ARCHITECT'S ADDENDUM

Addendum Number: 03

RE: EAHS 2026 Secured Entrance

Subject: Addendum 03 to the Construction Documents for the East Aurora High School 2026 Secured Entrance Project.

2 FIRST FLOOR - MAIN ENTRANCE DEMOLITION PLAN - AREA B
1/8" = 1'-0"

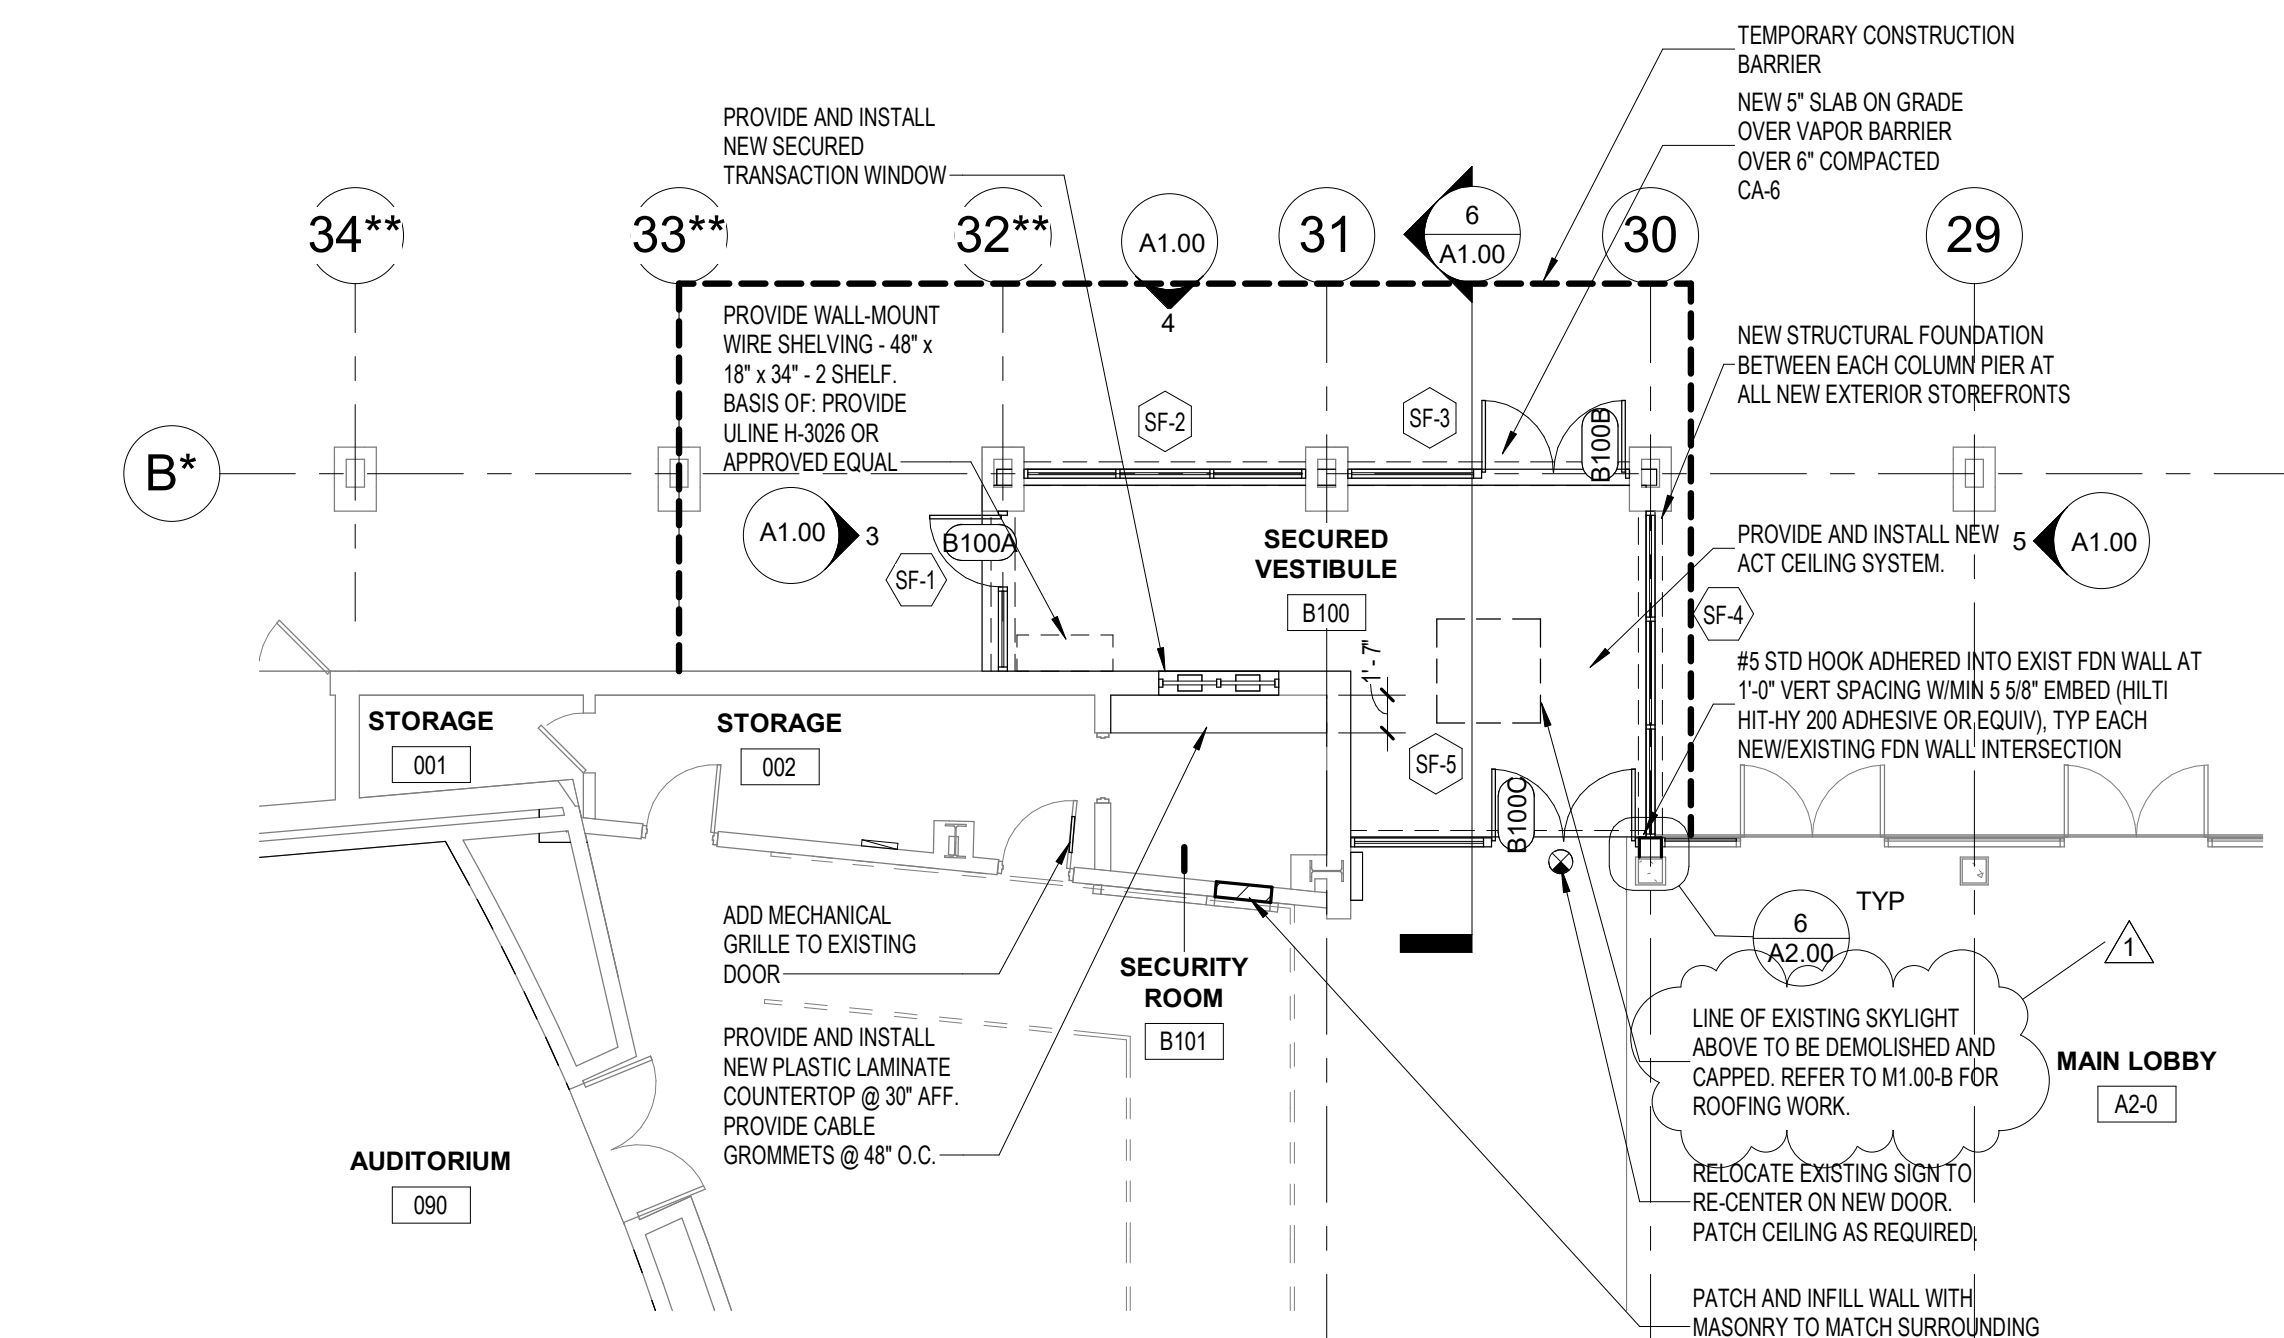
- 1) Sheet A1.00 – Partial First Floor Plan – Area B
 - **REVISED** Existing Conditions Photograph, Elevations, and New Work Plan. Refer to clouded regions on the attached drawing sheet.
- 2) Sheet A2.00 – Interior Elevations, Storefront Elevations, Wall Types, & Details
 - **REVISED** Glazing Notes and Legend, Alternate Descriptions, Storefront Elevations, and Detail 5 – Typical Header Detail – Main Entrance. Refer to clouded regions on the attached drawing sheet.
